Sidem Nr.	Reference nr.
Audi Tie rod end	37630	4F0 419 811 E

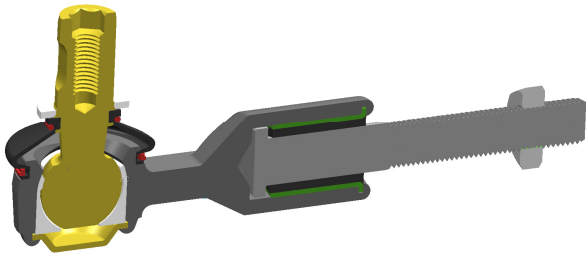
Problem:

- Play on Ball joint
- Silent block tears out

Solution:

- To prevent water-infiltration a new dustcover is designed with a perfect fit along the rod.
- A new rod is designed with an improved neck shape to ensure tight closing of the dustcover during movement.
- Extreme dynamic strain causes early damage of the metal rubber bonding, the design of the inner bushing is Modified to improve load capacity.
